Response to Submissions
in support of a
Section 75W Modification of
Project Approval PA08_0212

New Berrima
Clay/Shale Quarry

R.W. CORKERY & CO. PTY. LIMITED

September 2015

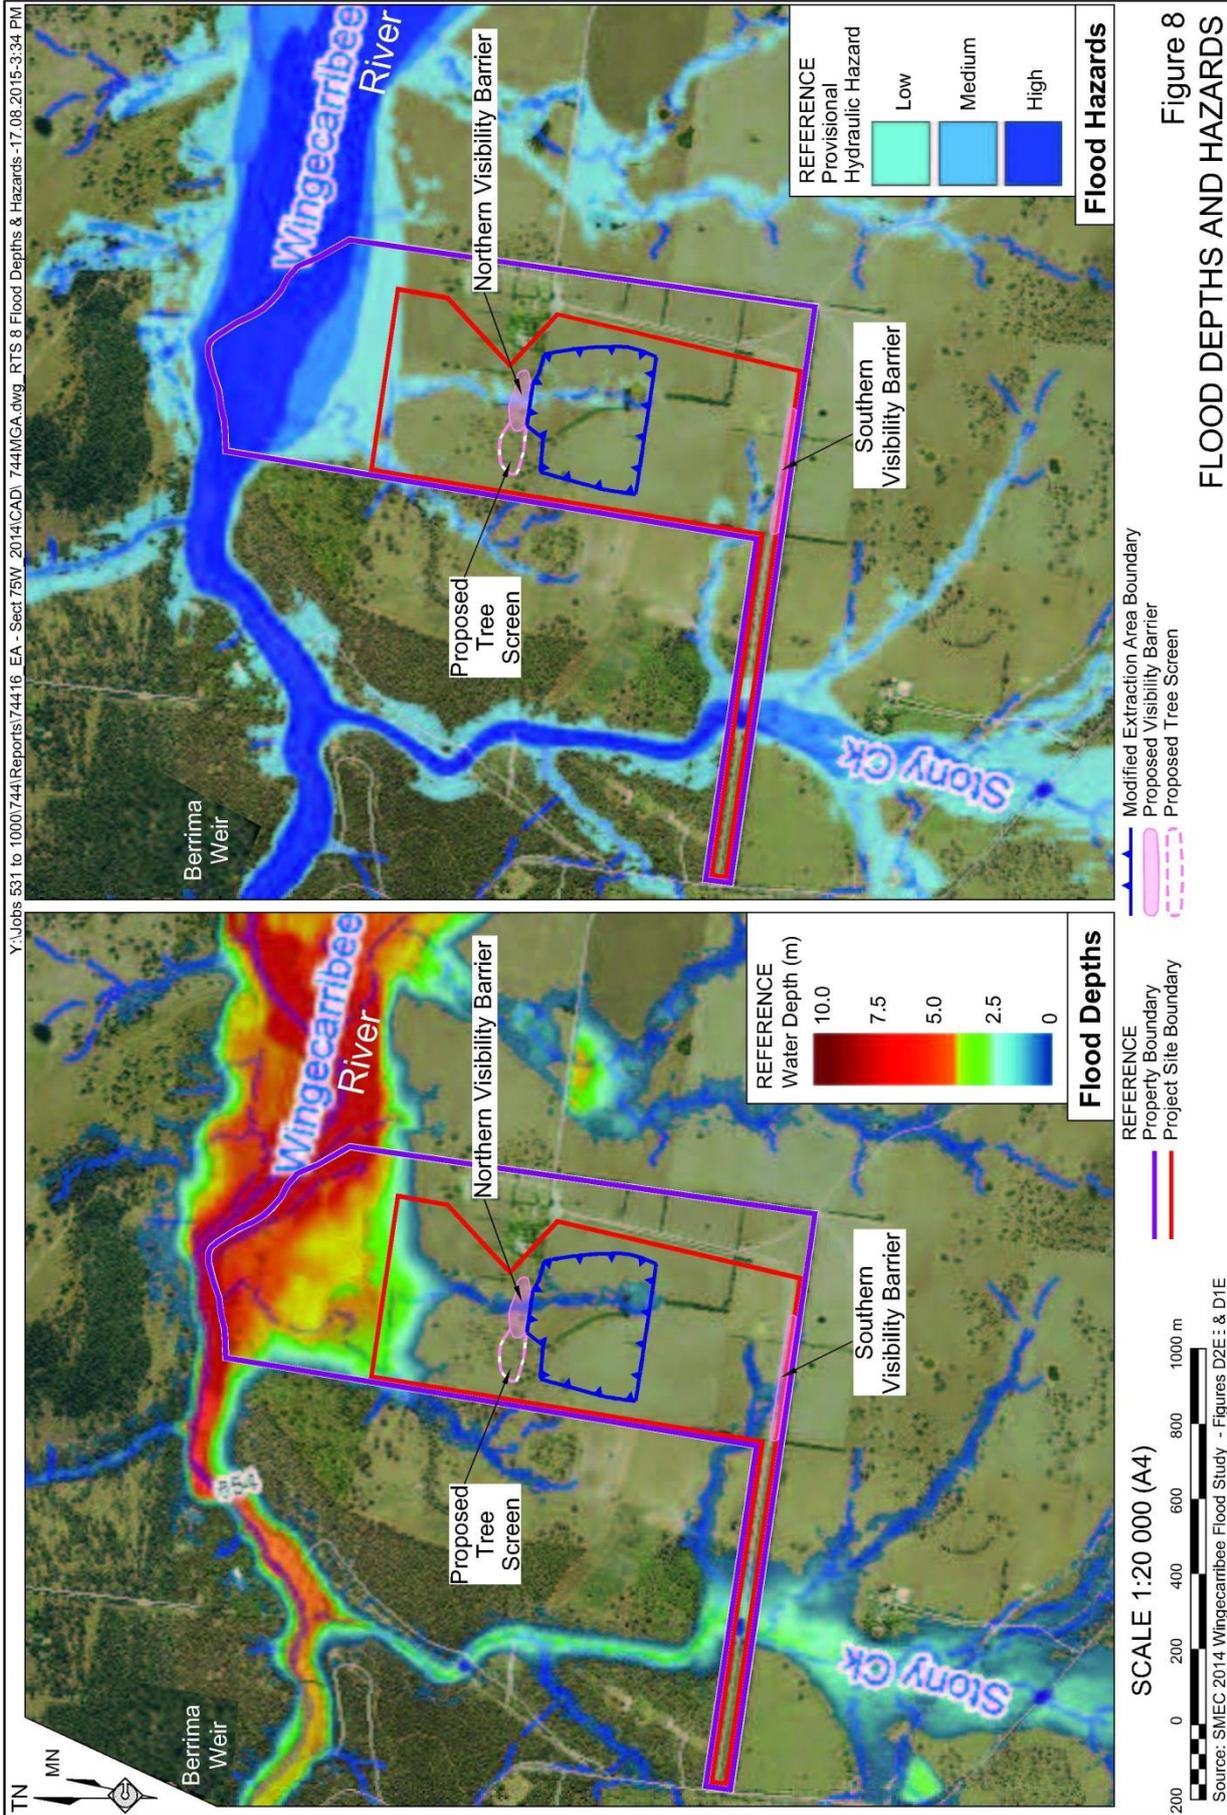
Representative Comment(s)

At the outset, OEH's statement that "the proposed development occupies flood prone land" is incorrect. It is acknowledged that the Project Site Boundary lies within flood prone land but none of the approved or modified extraction area lies within flood prone land. This observation is also documented in Appendix 6 (Section 4.6) i.e. the updated Surface Water Assessment (see **Attachment 1** to this document).

Figure 8 presents the results of flood modelling undertaken by SMEC (SMEC, 2014) on behalf of Wingecarribee Shire Council, with the proposed extraction area superimposed, highlighting that in a 1 in 100 year annual exceedance probability (AEP) flood would see runoff from the catchment in which the extraction area is located extending laterally within the watercourse. Clearly, the presence of the extraction area across this watercourse would reduce the extent of flow towards the Wingecarribee River during such a flood.

Figure 9
STAGES 1-4 CONSTRUCTION
AND OPERATIONAL WATER
MANAGEMENT STRUCTURES

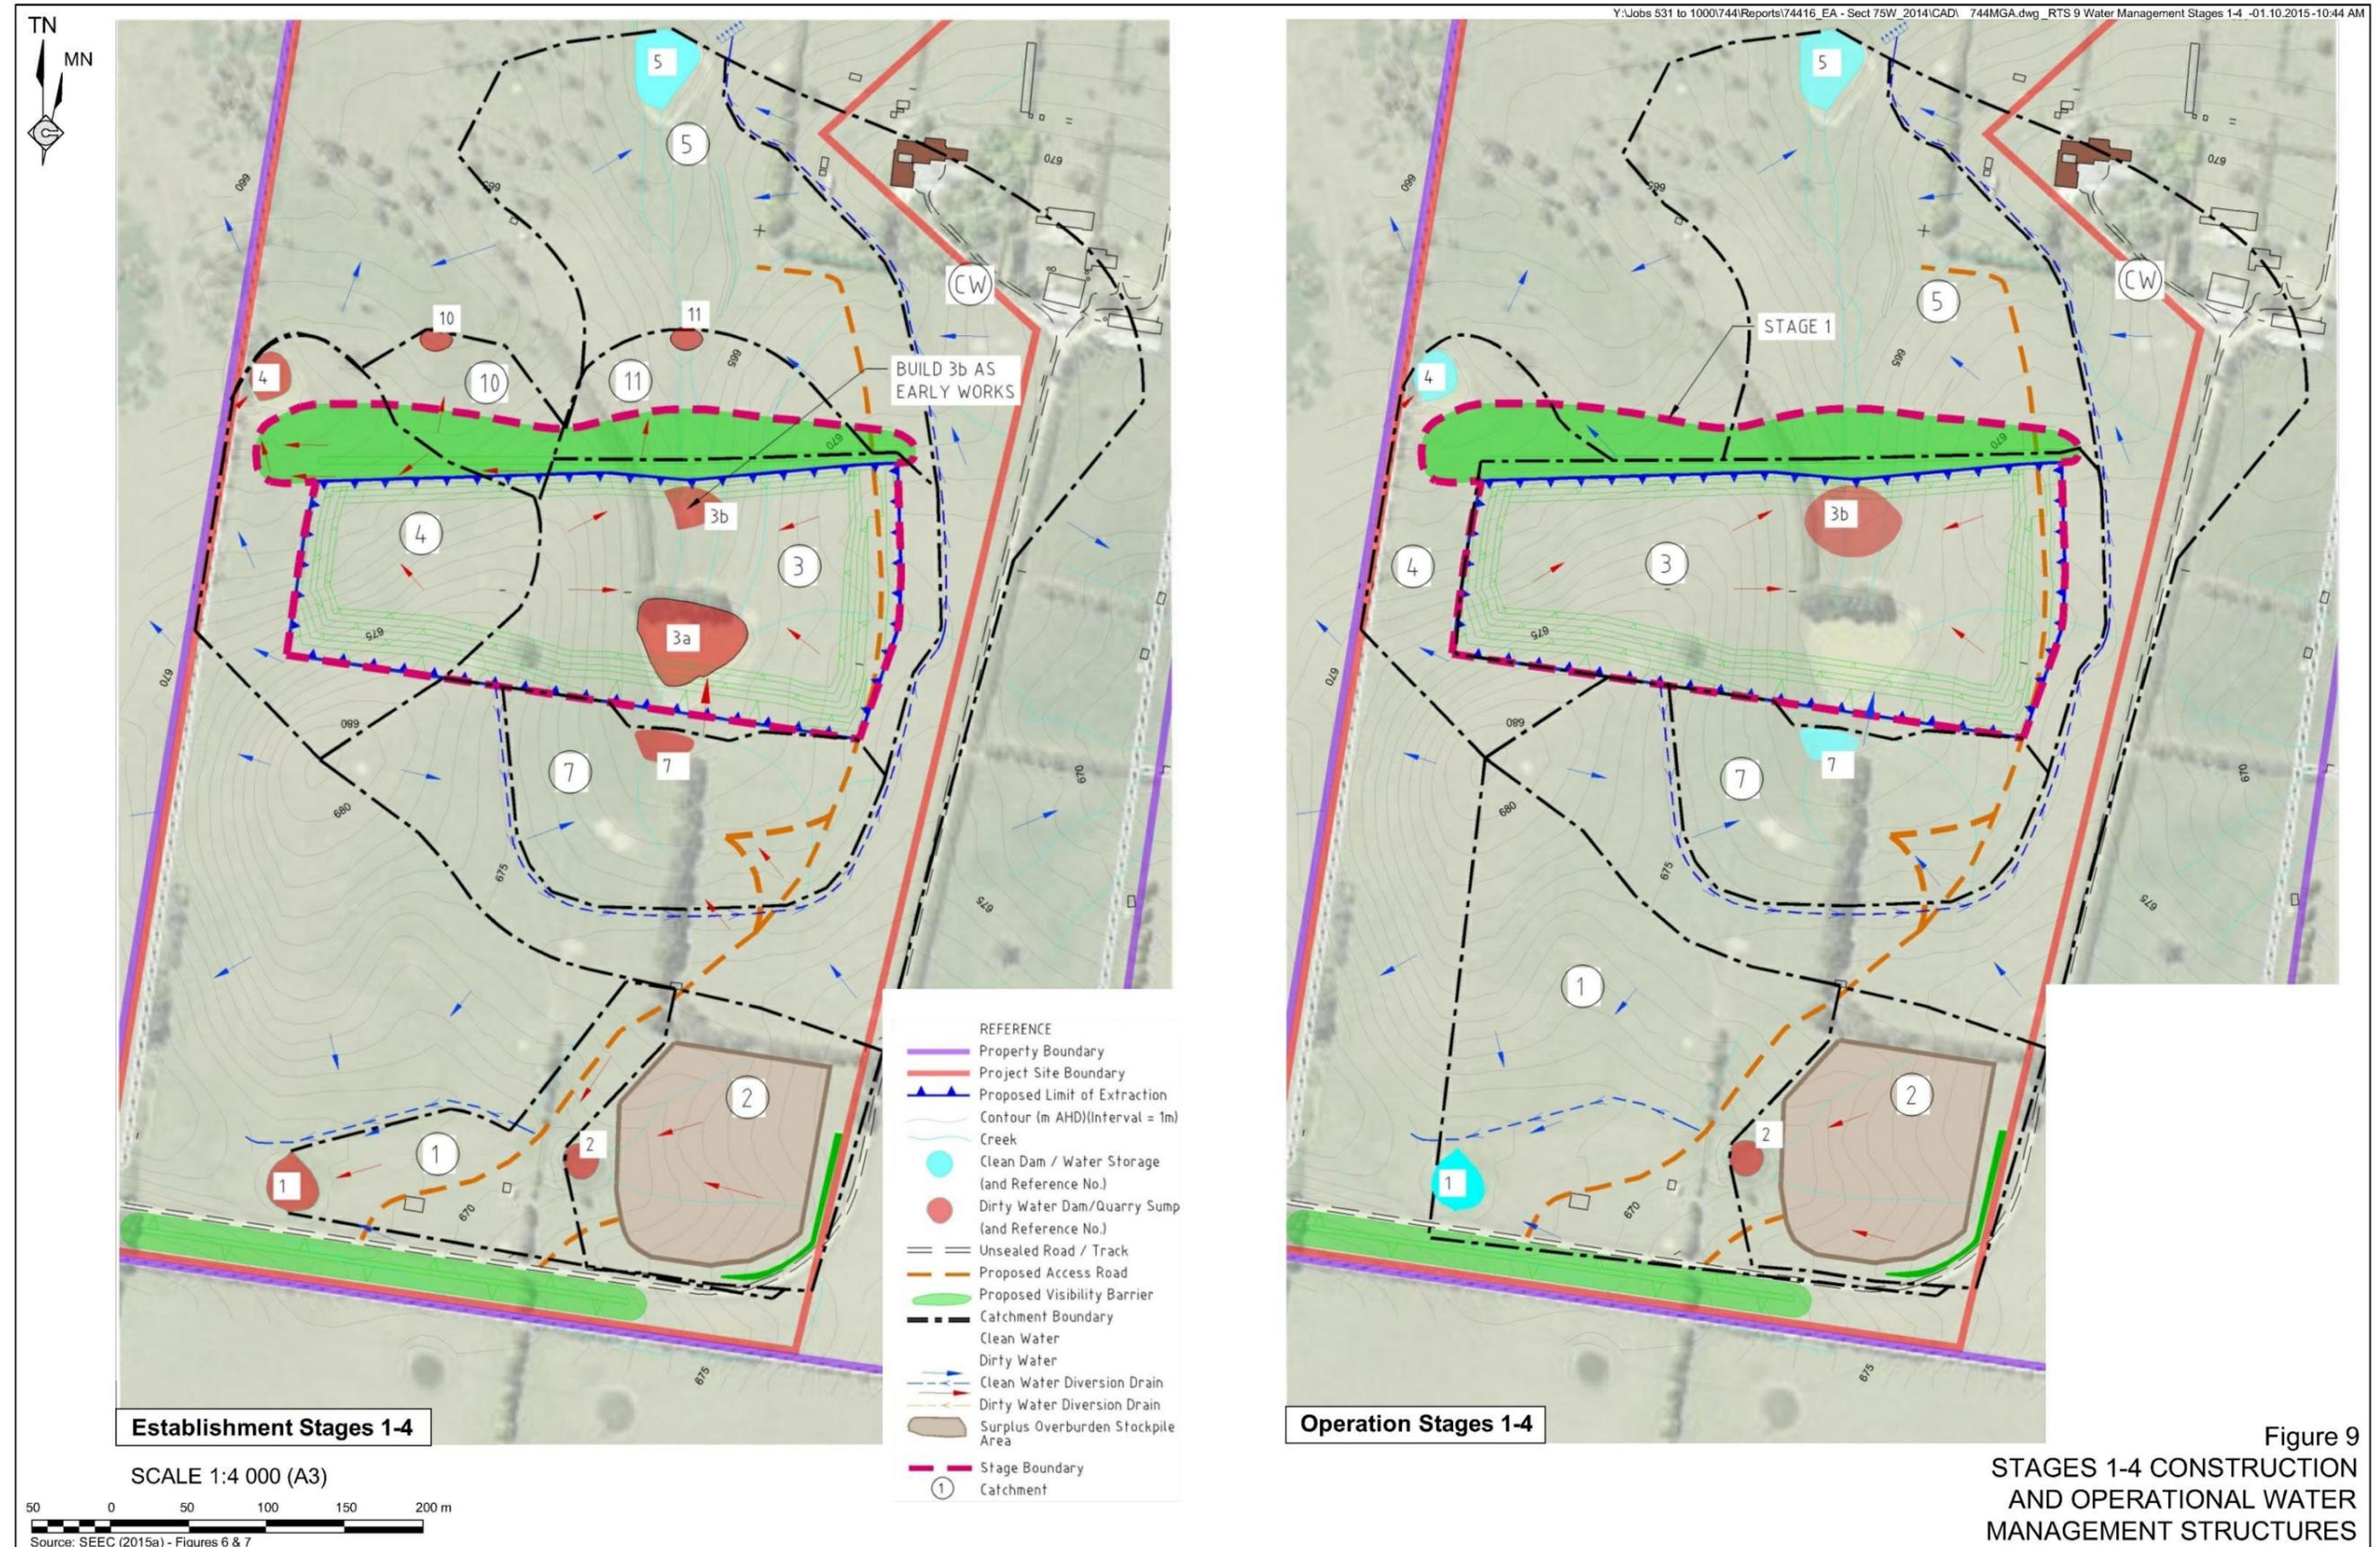
Representative Comment(s)

Figure 2 (Page 7) presents the locations of the main surface water management structures, with **Figure 9** and **10** providing the locations of clean water and dirty water structures during the four distinct periods of the Proposal, being:

A description of all revised water management structures displayed on **Figures 9** and **10** that are included within the harvestable rights calculations are outlined as follows, with **Table 2.1** providing a summary of dam capacities over the life of the Proposal, including the final landform. All other dams, i.e. Dams 9, 10 and 11 would effectively be short-term sediment basins.

Figure 11: Bowral Quarry – Mittagong Rivulet Diversion Channel

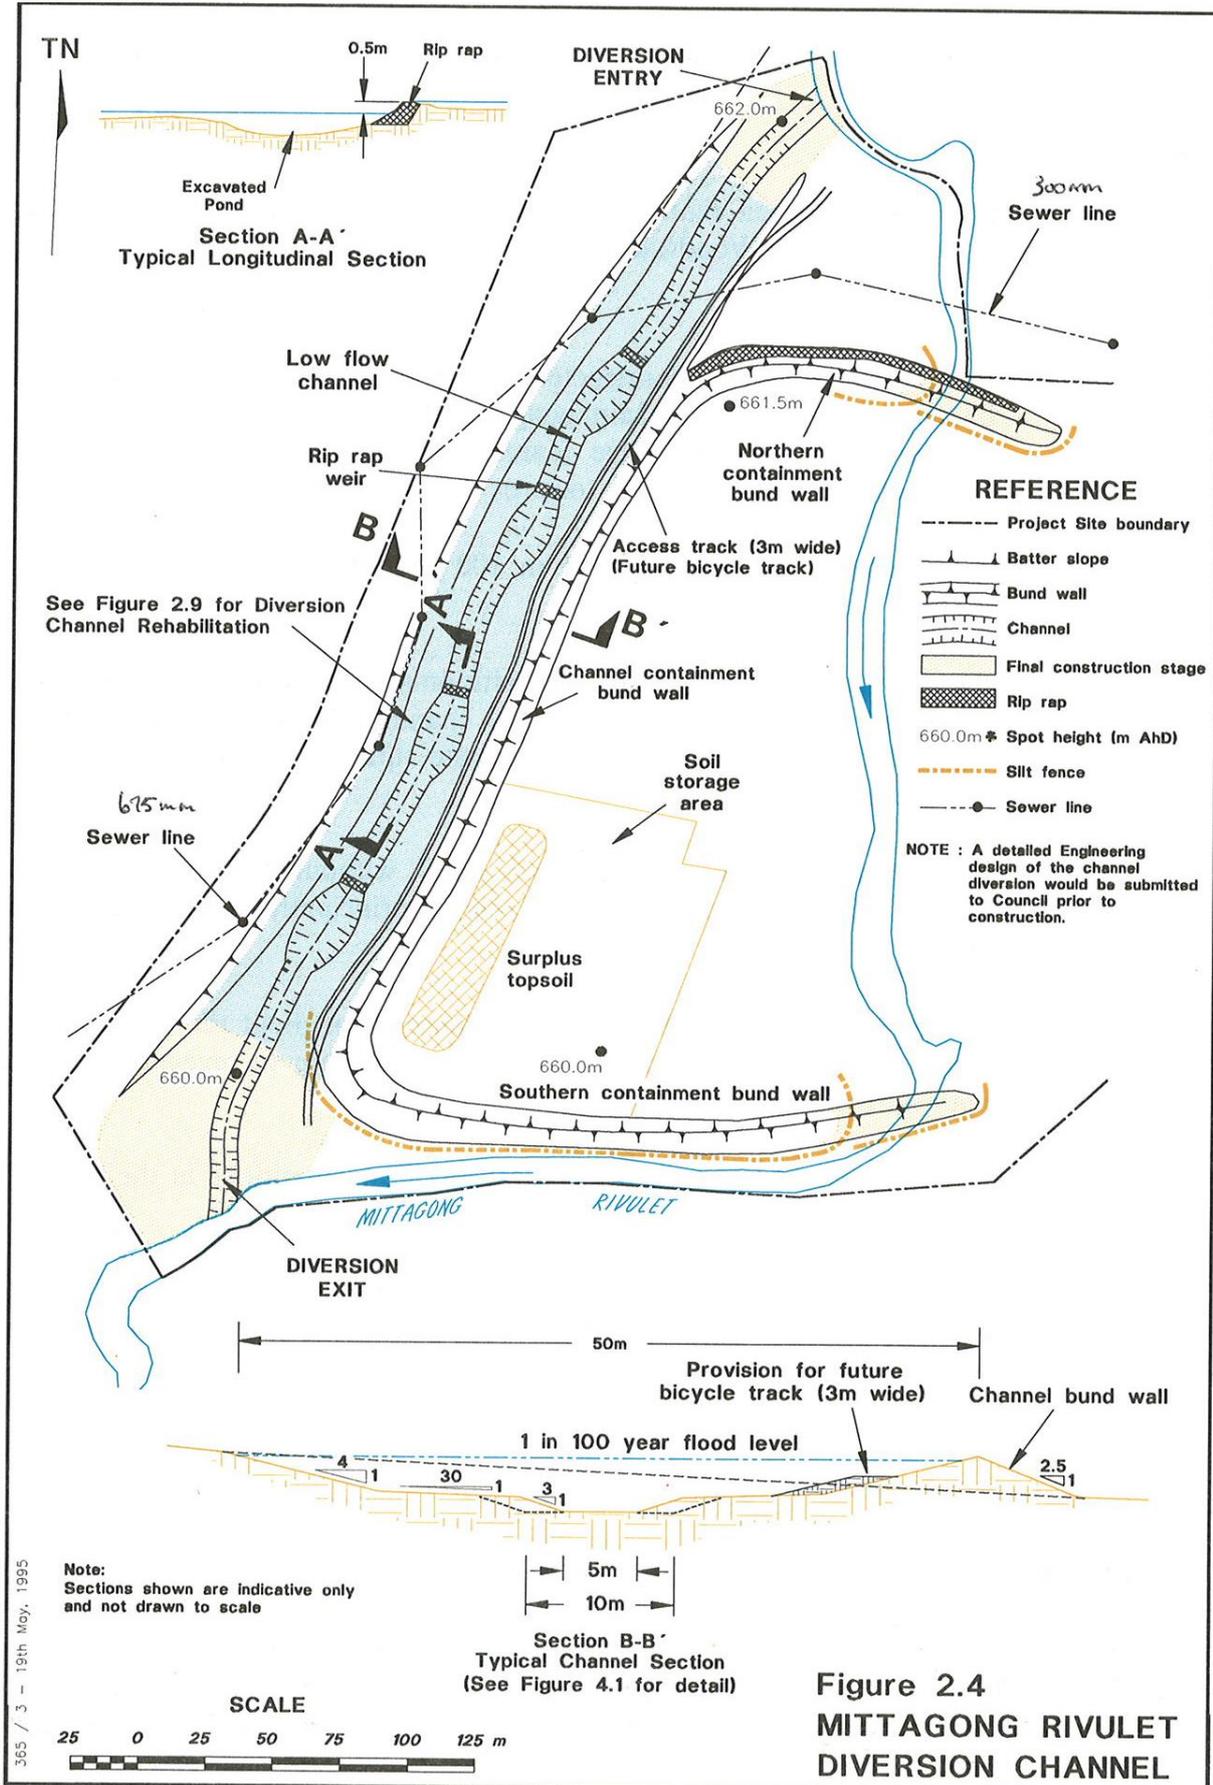
The proponent should provide an assessment of the likelihood and scale of perched water tables expected to be encountered, including a risk assessment to groundwater resources, including consideration of the scale of the potential volume of groundwater that could be intercepted.

Austral's experience at its Bowral Quarry adjacent to the Bowral Brick Plant has provided an excellent understanding of the potential for groundwater intersections and perched water levels, particularly in close proximity to a substantial watercourse. The western boundary of the Bowral Quarry is approximately 25m from the centre of the Mittagong Rivulet (a watercourse with a catchment above the Quarry of 22km²). The Mittagong Rivulet is a tributary of the Wingecarribee River. The attached **Figure 11** (1995 EIS Figure 2.4) and **Figure 12** (1995 EIS Figure 2.6) display the proximity of the existing Bowral Quarry to the Mittagong Rivulet.
